# Access Compliance Report

## Public Rights-of-Way

### (Curb Ramps)

Intersection ID: 50344	Main Street: KELBURN_LN	Cross Street: FENWAY_DR	Location: NW
ADA ID: BAFAB0364EC8	Ramp Type: Perp	Initial Pass/Fail: Fail	Overall Compliance: No
		Severity Score: 10

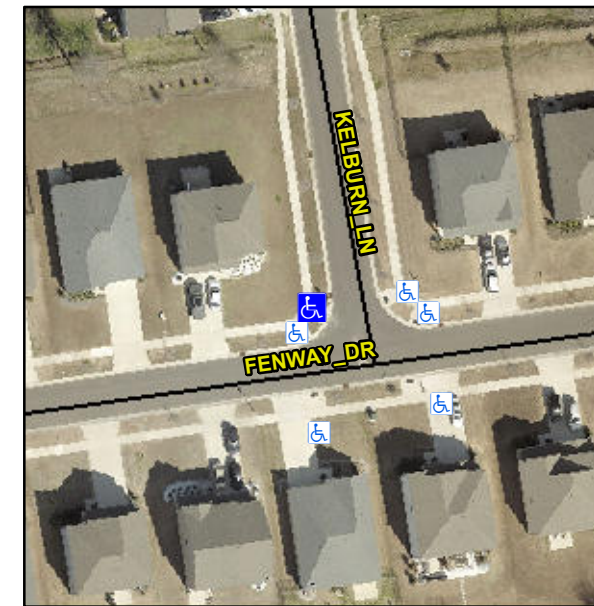
**Not Found, R304.5.1, R304.5.3**

Compliance	Description	Data	Compliance	Description	Data
N/A	Ramp Length (in)	100.0	Yes	Ramp Slope (%)	6.5
No	Ramp Width (in)	47.0	No	Ramp XSlope (%)	4.0
N/A	Flare Type LT	N/A	N/A	Flare Type RT	N/A
N/A	Flare Slope LT (%)	N/A	N/A	Flare Slope RT (%)	N/A
N/A	Flare Traversable LT?	N/A	N/A	Flare Traversable RT?	N/A
N/A	Landing Length (in)	N/A	N/A	DWS Provided?	N/A
N/A	Landing Width (in)	N/A	N/A	DWS Contrast?	N/A
N/A	Landing Slope (%)	N/A	N/A	DWS Length (in)	N/A
N/A	Landing X Slope (%)	N/A	N/A	DWS Full Width?	N/A
N/A	Landing Curb? (Y/N)	N/A	N/A	DWS Offset (in)	N/A
N/A	Shared Landing?	N/A			
N/A	Gutter Ponding?	N/A	N/A	Gutter Slope (%)	N/A
N/A	Gutter Lip Ht (in)	4.0	N/A	Gutter X Slope (%)	N/A
N/A	Painted X Walk1?	No	N/A	Painted X Walk2?	N/A
	X Walk 1 Direction	To E		X Walk 2 Direction	N/A
N/A	X Walk 1 Width (in)	N/A	N/A	X Walk 2 Width (in)	N/A
	X Walk 1 Slope (%)	3.1		X Walk 2 Slope (%)	N/A
	X Walk 1 X Slope (%)	3.8		X Walk 2 X Slope (%)	N/A

**Remove & Replace Entire Ramp.**
